TECHNICAL MEMORANDUM

RE: **ADDENDUM NO. 2 - RI/FS WORK PLAN
SUPPLEMENTAL RI
NORTH MARINA AMERON/HULBERT SITE
EVERETT WASHINGTON**

North Marina Ameron/Hulbert Site
 Supplemental RI Work Plan
 Port of Everett, Washington

Figure
1

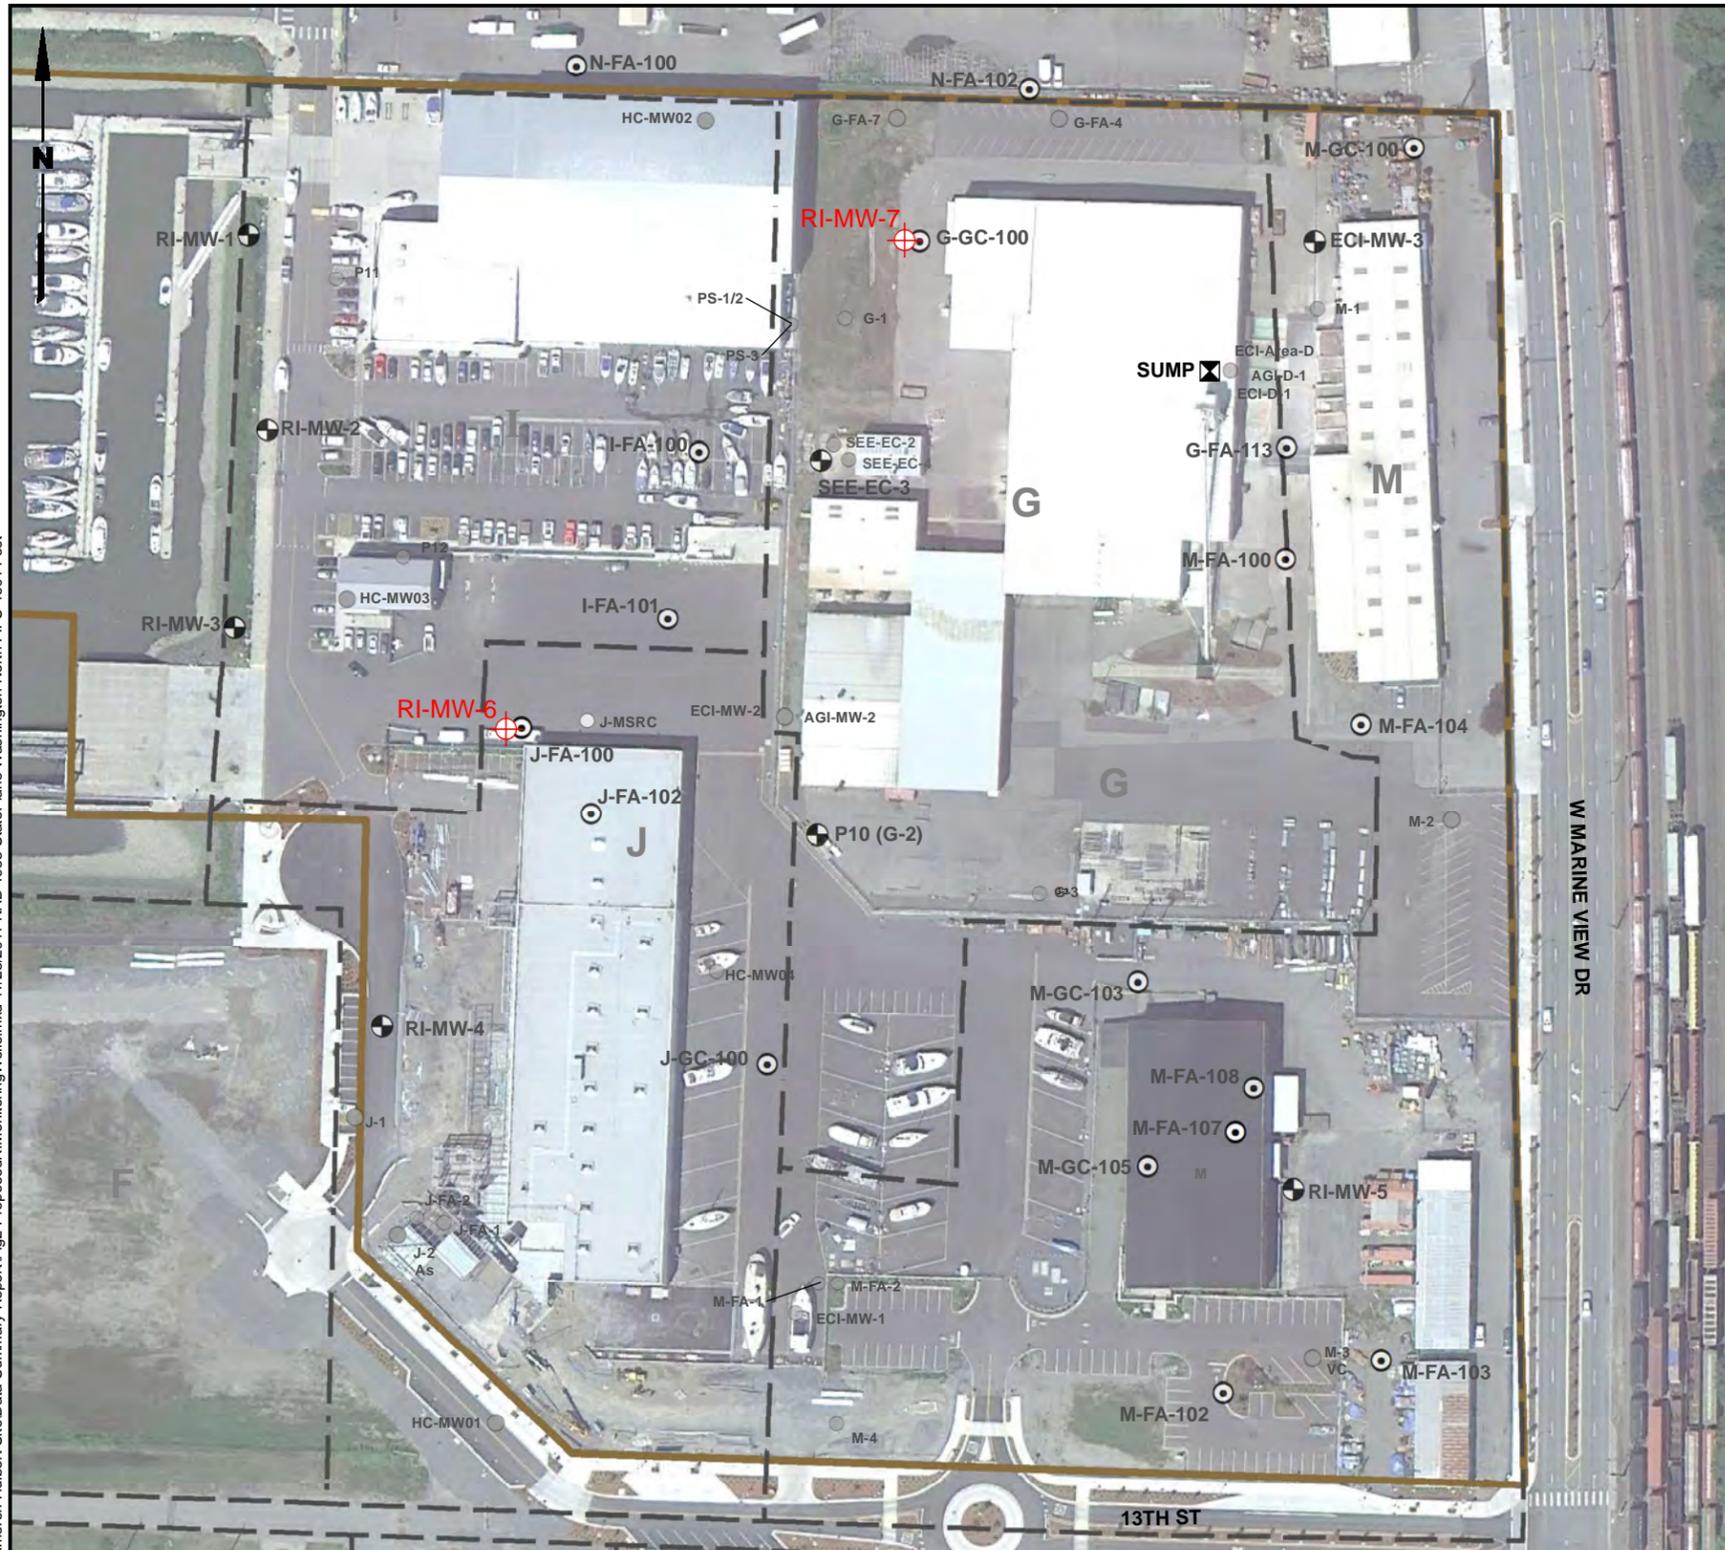
- Advance one shallow soil boring (G-FA-105a) in the northwestern portion of Area G to evaluate the vertical extent of metals in the vicinity of G-FA-105.
- Advance five borings (G-FA-115, G-FA-115a, G-FA-115b, G-FA-114, G-FA-114a) in the vicinity of the oil-affected area along the north Site boundary to determine whether soil

contamination encountered on the Norton Industries property to the north is also present on the Site.

- Advance two shallow borings (G-GC-113, G-GC-114) within the Pole Finishing and Dry Storage Building to determine whether shallow soil was affected by operations that occurred in this area, which was unpaved prior to construction of the building.

- Advance five shallow borings (M-GC-102a, -102b, -102c, -102d, -102e) in the vicinity of M-GC-102 to evaluate the lateral bounds of metals in shallow soil in this area.

- Advance two shallow borings in the vicinity of M-FA-103 (M-FA-103c, M-FA-103d) to evaluate the lateral bounds of metals in shallow soil in this area.

- Advance three soil borings (M-FA-102f, -102g, -102h) in the vicinity of M-FA-102 to evaluate the lateral bounds of metals and carcinogenic polycyclic aromatic hydrocarbons (cPAHs) contamination in subsurface soil.

- Advanced one shallow boring (M-GC-107) in the storage yard to the north of the Ameron sublease building to determine whether shallow soil was affected by operations that occurred in this area which was unpaved prior to construction of the building.

The locations for these additional explorations are shown on Figure 1. Table 1 summarizes the planned depth of exploration and proposed analyses for each location. All soil explorations for the Supplemental RI will be advanced using direct-push drilling equipment. Soil samples will be analyzed for the parameters identified below unless field screening (conducted in accordance with the RI Work Plan) indicates additional testing is warranted based on the presence of potential contamination. Blind field duplicate soil samples will be collected and analyzed in accordance with the RI Work Plan. All samples will be collected and preserved consistent with the method-specific requirements presented in Table F-2 for the Final RI/FS Work Plan. Analyses will be conducted within the specified holding times, also presented in Table F-2 of the Final RI/FS Work Plan. In addition, the analyses will be conducted consistent with the quantitation limit goals identified in Table F-3 of the Final RI/FS Work Plan.
